1998 Annual Report
Monitoring Event 10
Building 95
Naval Air Station, Brunswick, Maine

Response to Comments on 1997 Annual Report and Monitoring Event 10 Report

**RESPONSE TO COMMENTS FROM
MAINE DEPARTMENT OF ENVIRONMENTAL PROTECTION
ON 1997 ANNUAL REPORT, MONITORING EVENTS 8 AND 9, BUILDING 95,
NAVAL AIR STATION, BRUNSWICK, MAINE**

FIGURE 1-2
SITE PLAN

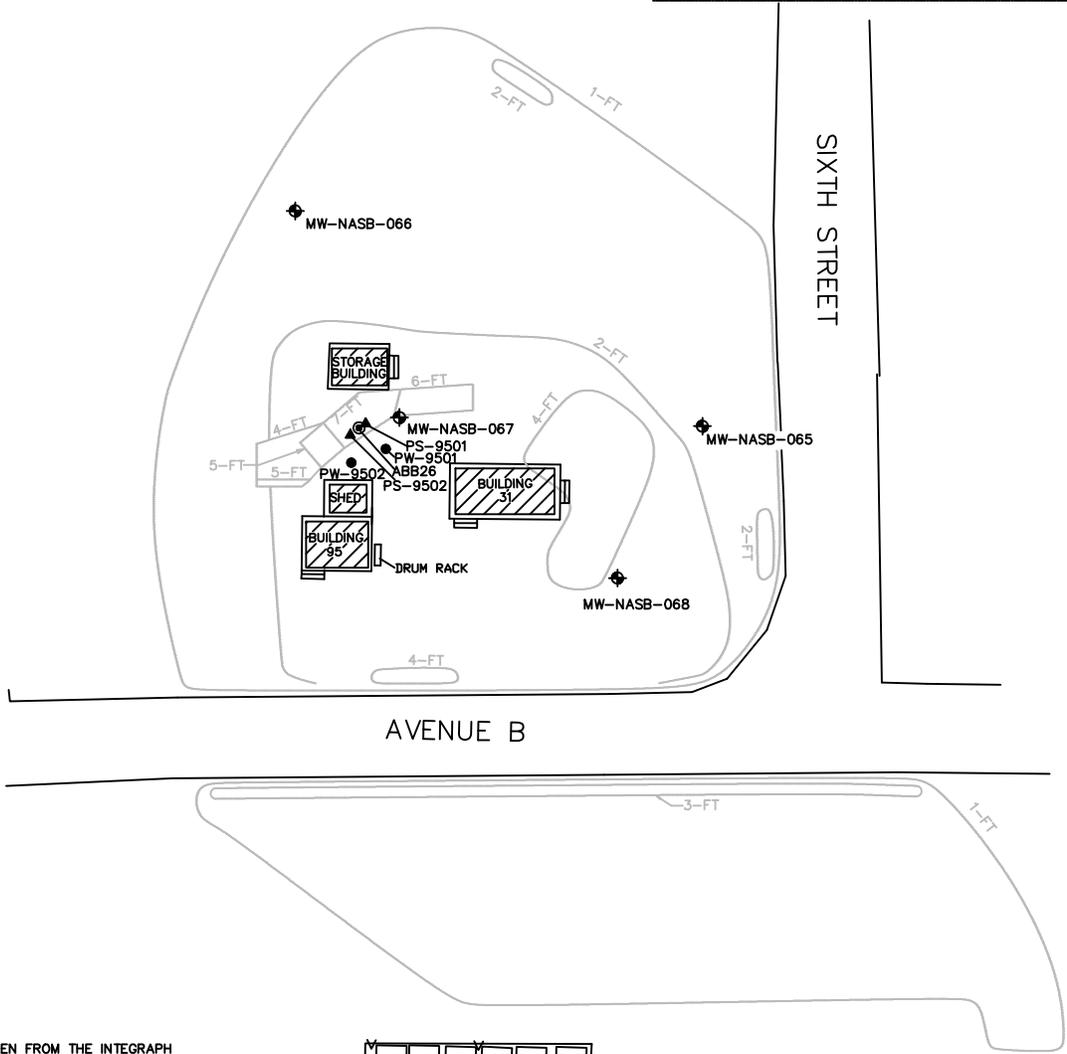
1. Why does Figure 2 have an approximate distance scale? A scale of 1.05 in. = 45 ft is very difficult to use, and projects a poor image to the public. A better base map is that of Figure 2-2 of the Draft Closure Report (January 1997).

Response—This comment is noted, and Figure 2 has been revised for the Draft 1998 Annual Report to include additional site details.

BUILDING 95 NAVAL AIR STATION BRUNSWICK, MAINE			FIGURE 3-7 INTERPRETED WATER TABLE ELEVATIONS, 2 NOVEMBER 1998		
PROJECT MGR CEM	DESIGNED BY SYC	DRAWN BY SAP	CHECKED BY PLN	SCALE AS SHOWN	DATE 5 APR 1999	PROJECT NO 29600.47	FILE No. B95NOV98

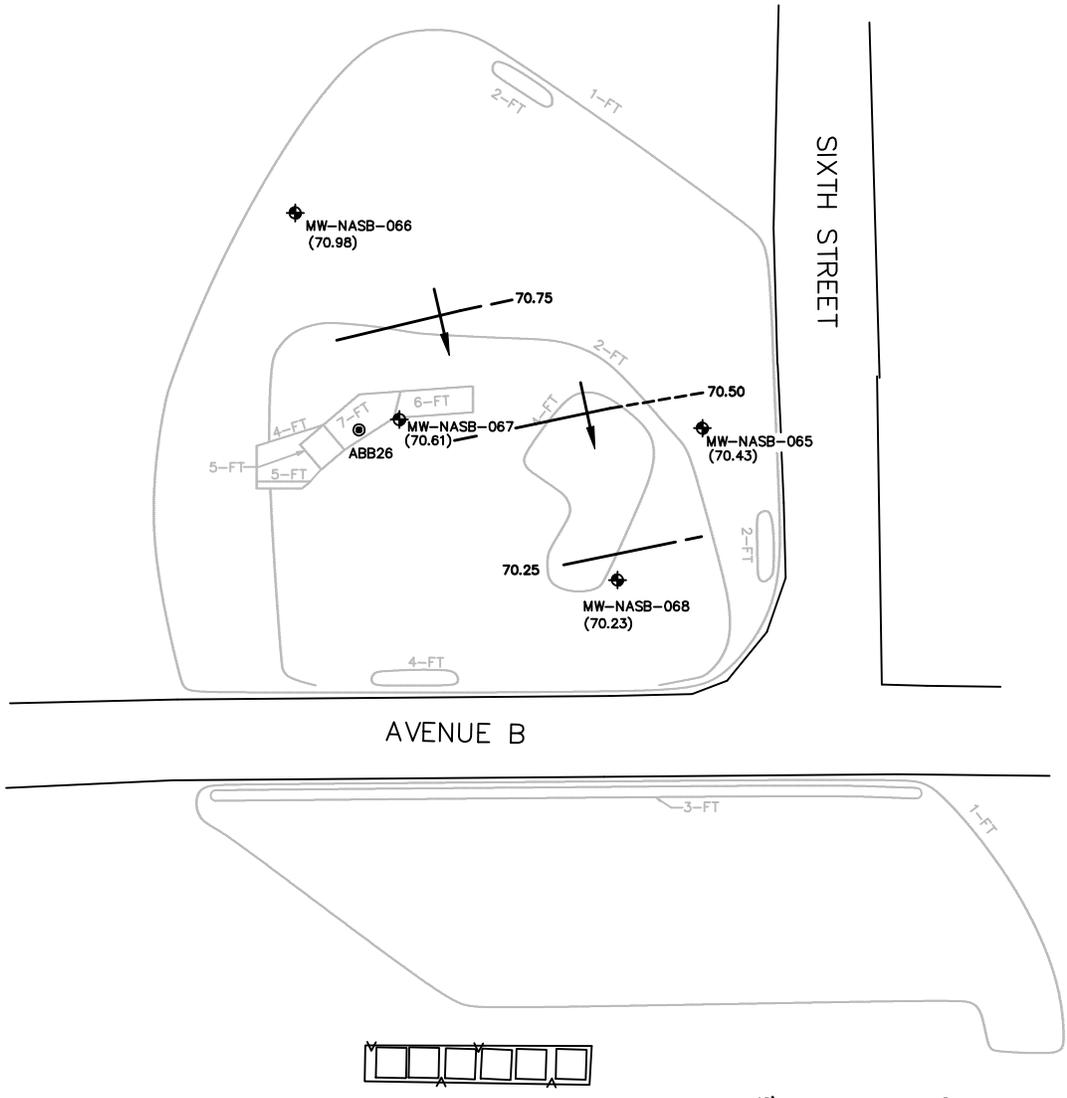
8. **Figure 3-7**—The configuration of water table contours is unrealistic. If the 69.25-ft contour does bend to the east as shown, the adjacent contours (69.0 and 69.5) must also have some easterly bend. Perhaps the measured water level elevation of MW-NASB-065 is erroneous. Please revise this map.

10. **Figure 3-7, Water Table Elevations, 4 November 1997**—The reason for curving the 69.25 elevation line only toward MW-NASB-065 is not clear. Ground-water gradients appear to be relatively constant in both magnitude and direction during the entire program. The only exception is Monitoring Event 9, in which the magnitude was about 25 percent less than the abnormal gradient of 0.01 ft/ft. This does not appear significant though.

Response—Changing the contours as indicated will not significantly impact inferred flow direction, therefore, no change is warranted on the referenced figure. Future figures will show increased contour curvature if warranted. No change was made to this figure.

Response—The 69.25-ft contour was curved in response to the measured elevation at MW-NASB-065 (69.20). The Navy agrees that this variation is not significant, and that generally consistent flow patterns are observed at Building 95. This figure has not been changed.
